# Wisconsin Department of Transportation

**Proposal #15: 2984-12-74, WISC 2024227**  
**C Milwaukee, N Holton St Phase 2**  
**Br Over Milw Rvr, Commerce, Water**  
**Local Street**  
**Milwaukee County**

This is Addendum No. 01, which provides for the following:

**ADDENDUM NO. 01**

Addendum No. 01  
 ID 2984-12-74  
 Revised Sheet 62  
 February 5, 2024

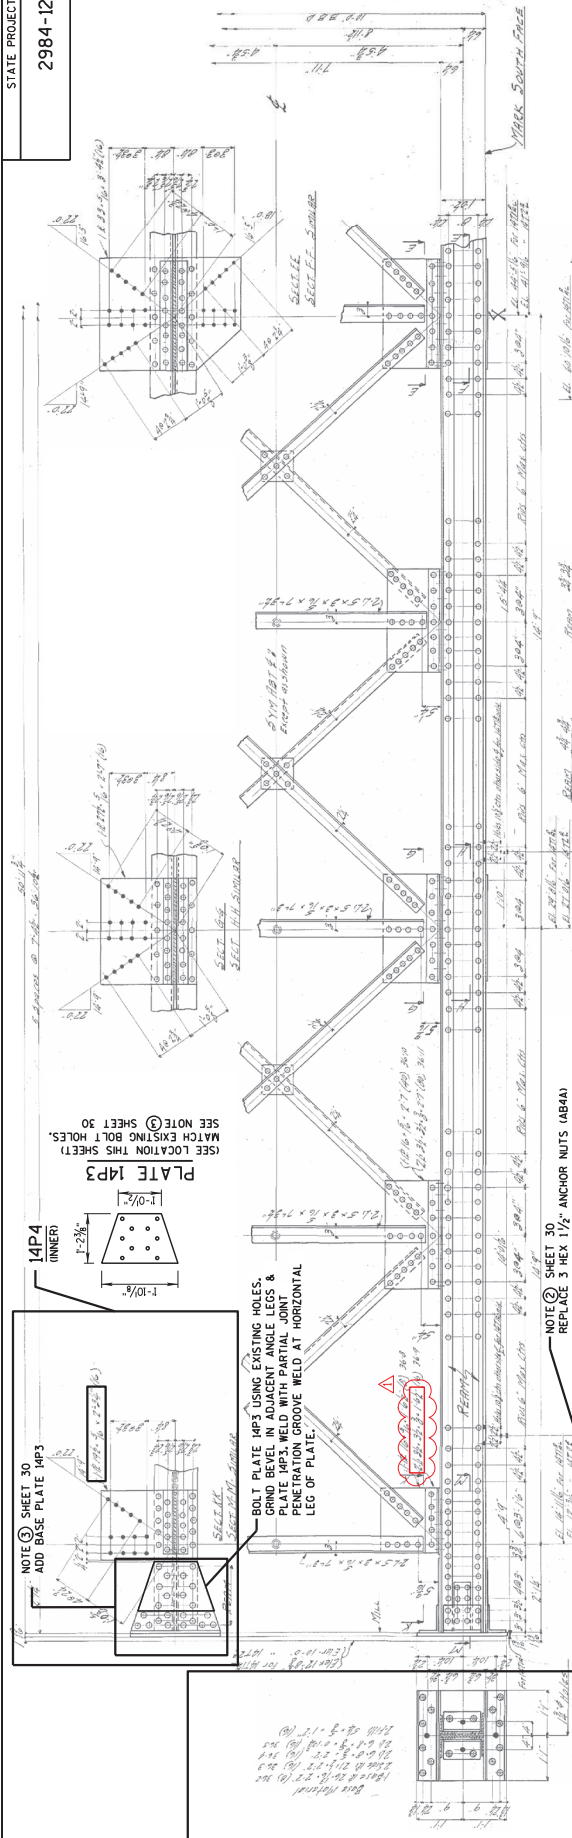
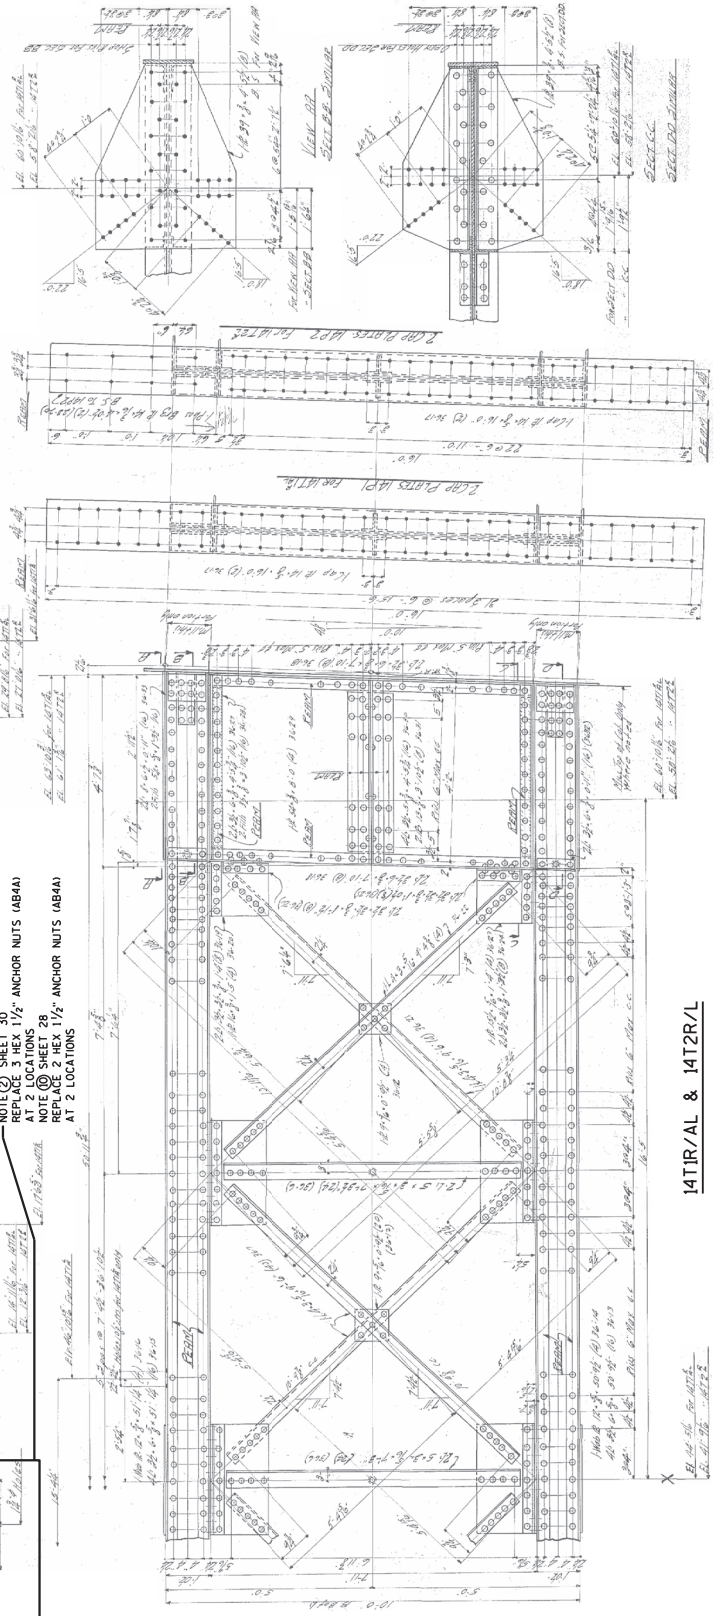
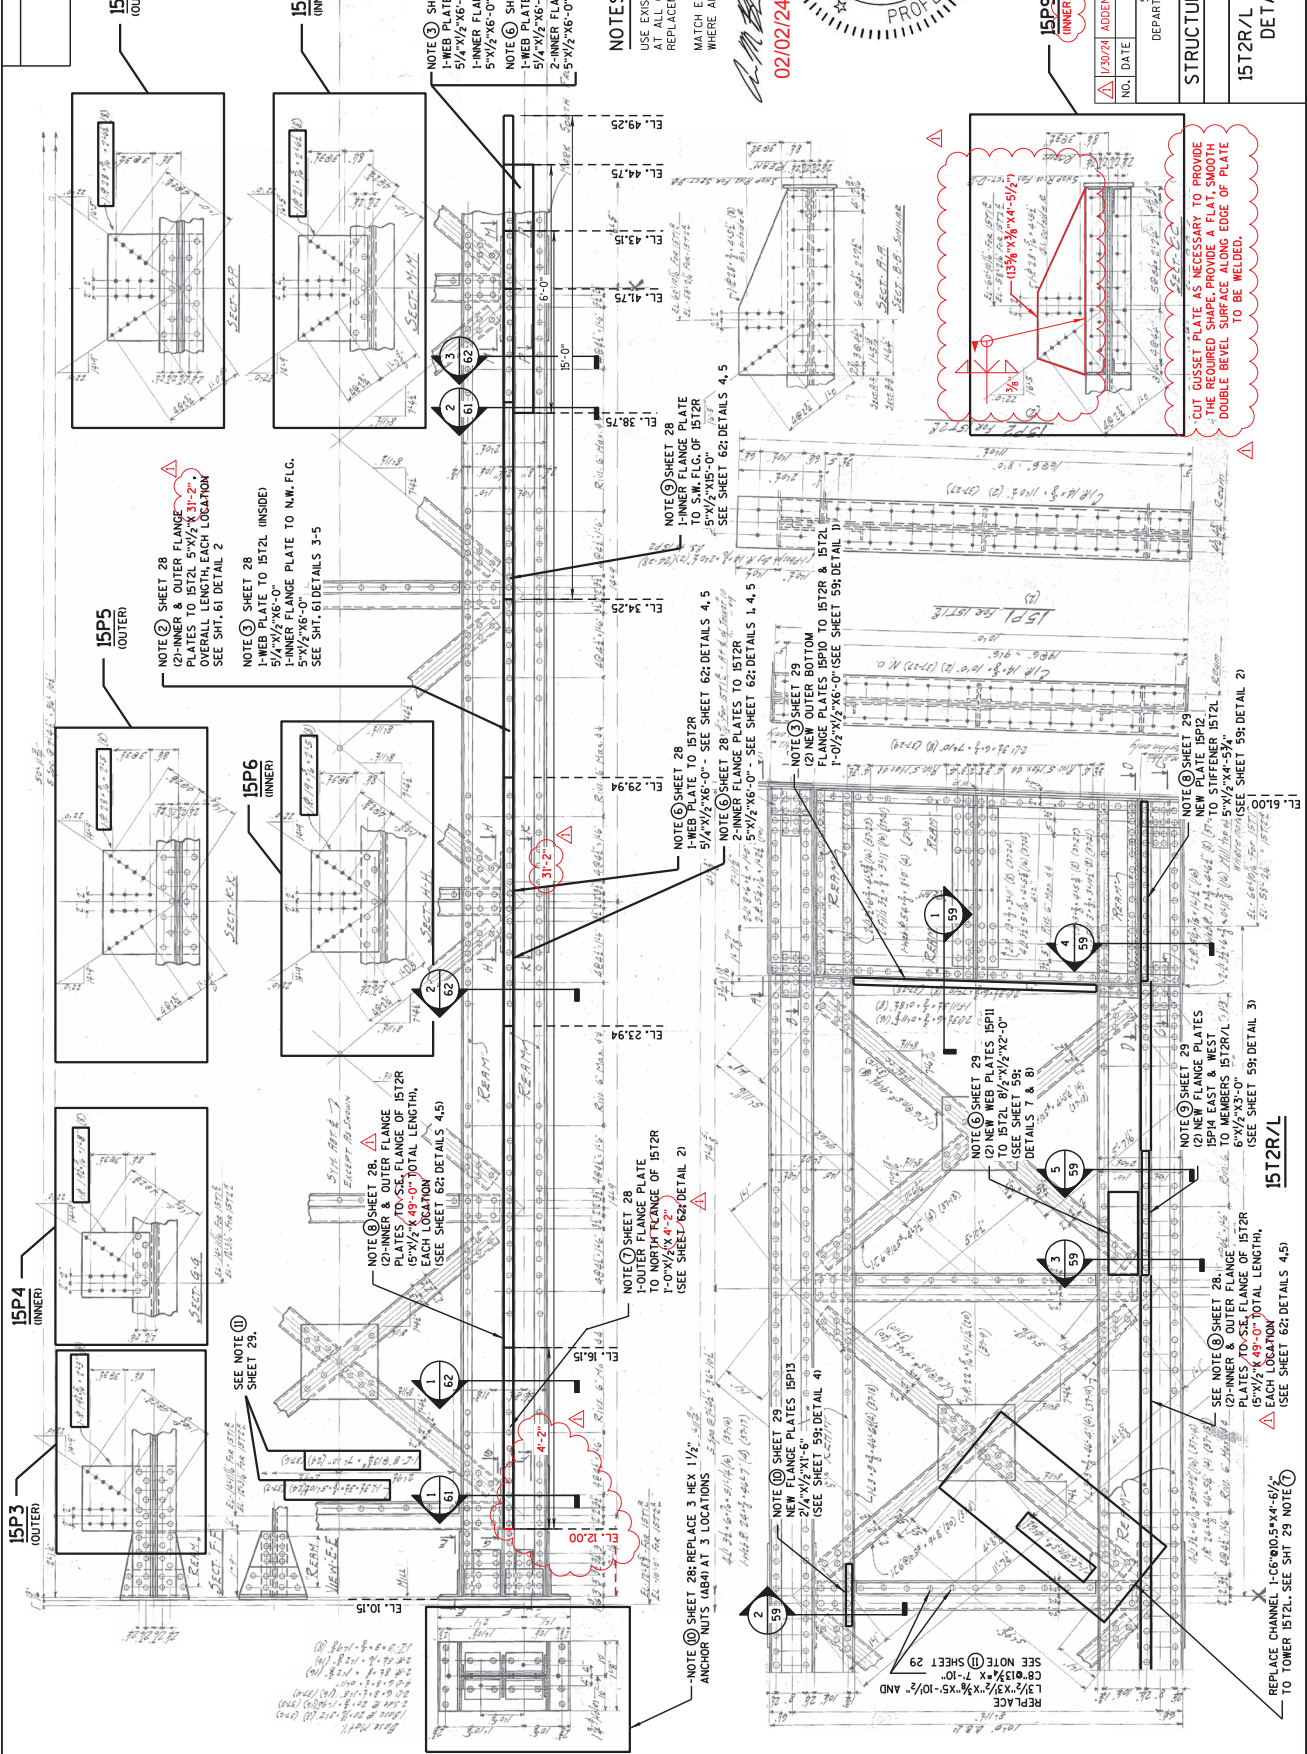
NOTE ③ SHEET 30  
 ADD BASE PLATE 14P3  
 (INNER)

BOLT PLATE 14P3 USING EXISTING HOLES.  
 WELD TO GUSSET PLATE 14P2 &  
 PLATE 14P3. WELD WITH PARTIAL JOINTS &  
 PENETRATION GROOVE WELD AT HORIZONTAL  
 LEG OF PLATE.

NOTE ② SHEET 30  
 REPLACE 3 HEX 1/2" ANCHOR NUTS (A844)  
 AT 2 LOCATIONS  
 WITH 2 HEX 1/2" ANCHOR NUTS (A844)  
 AT 2 LOCATIONS

Addendum No. 01  
ID 2984-12-74  
Revised Sheet 91  
February 5, 2024

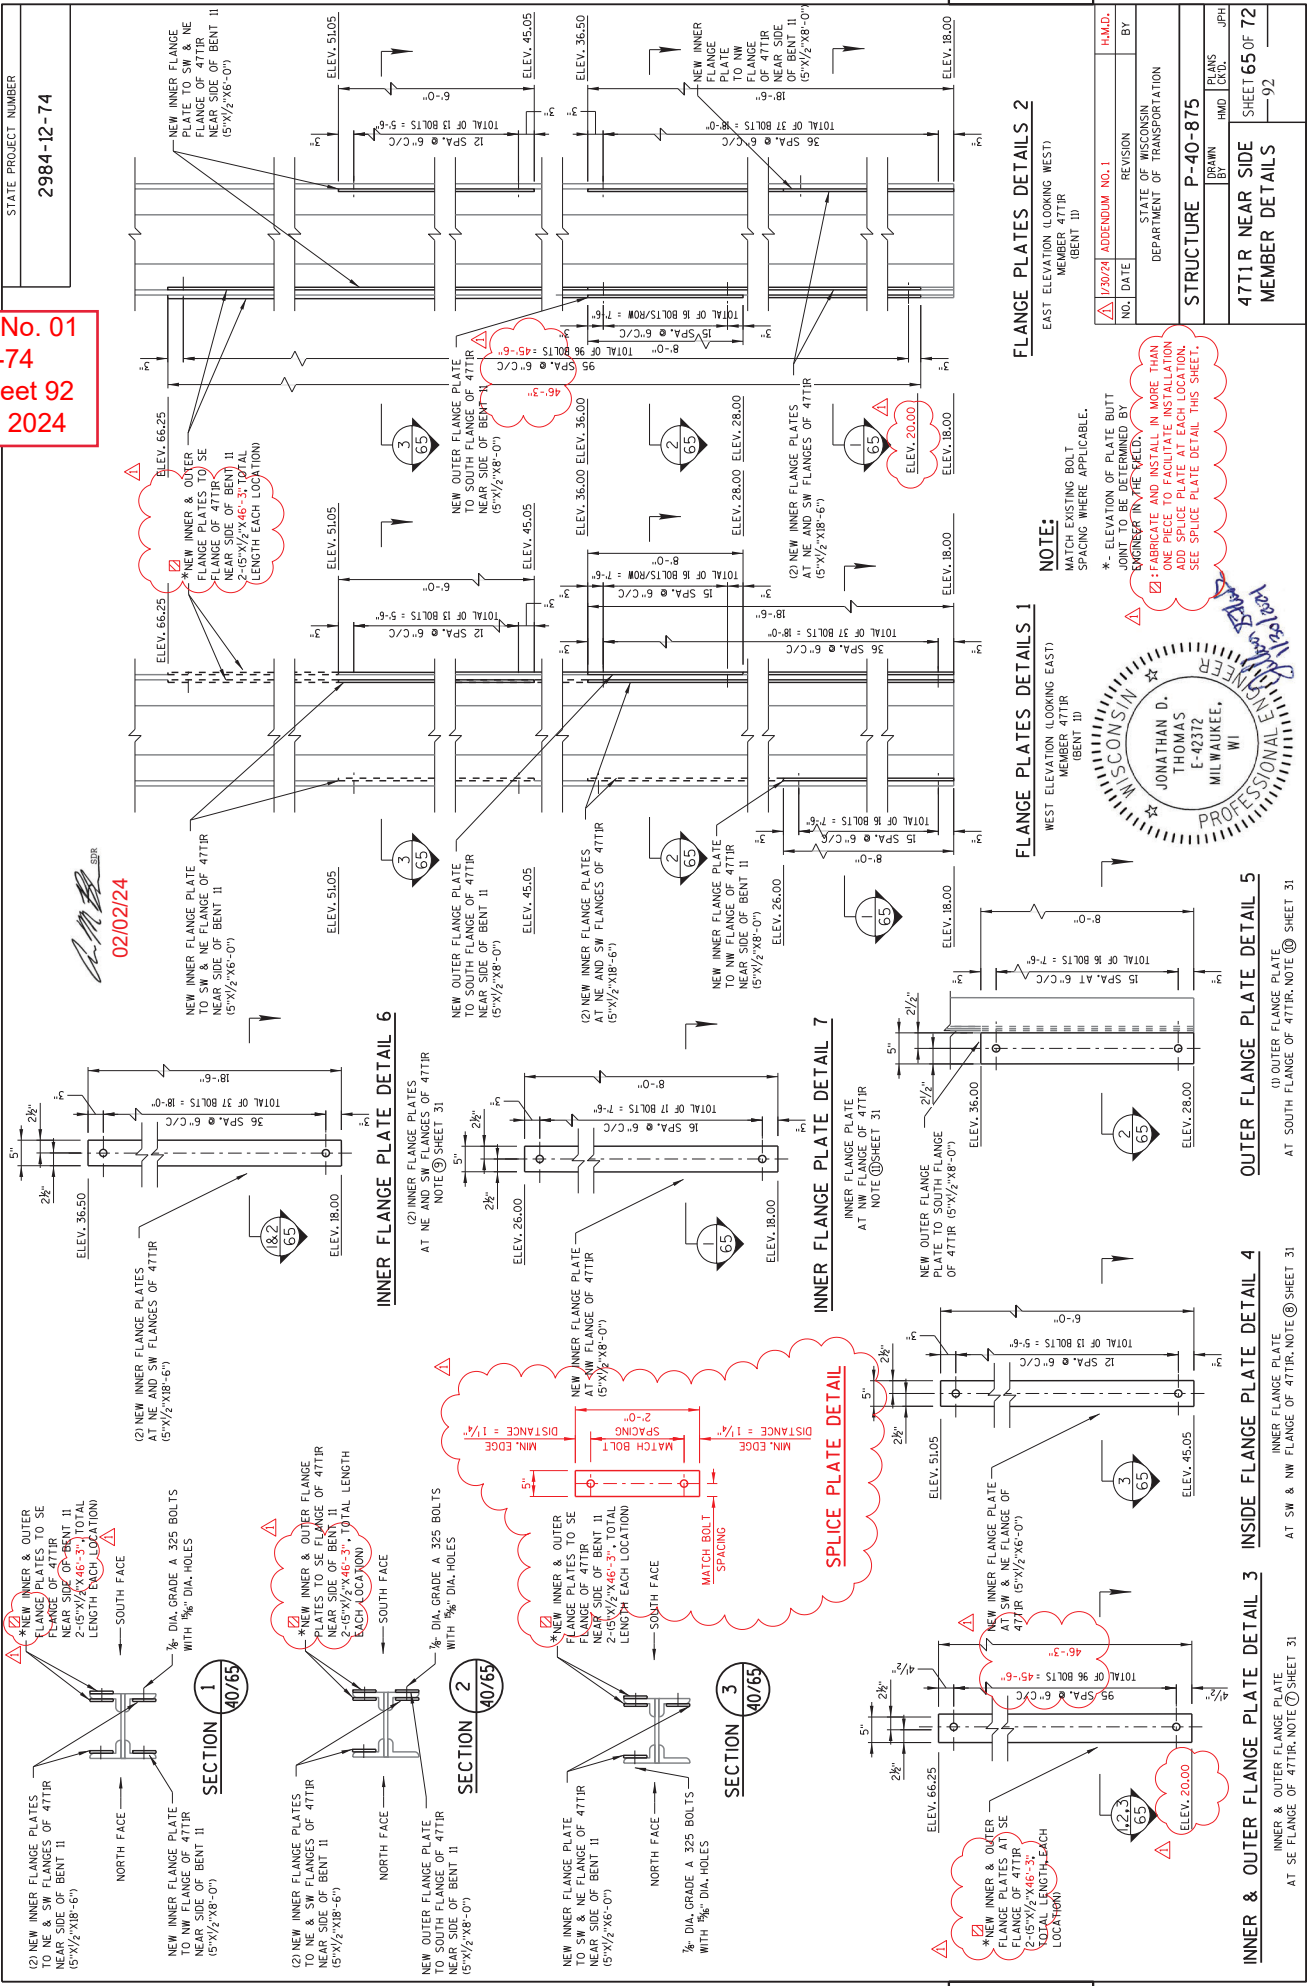
92	47T1R Near Side Member Details (updated details)
93	49T1 Far and Near Sides Member Details (updated details)
94	50T1 Far Side Member Details (updated details)
95	50T1 Near Side member Details (updated details)
96	51T1 Far Side Member Details (updated details)
97	51T1 Near Side Member Details (updated details)
98	52T1 Far Side Member Details (updated details)
99	52T1 Near Side Member Details (updated details)
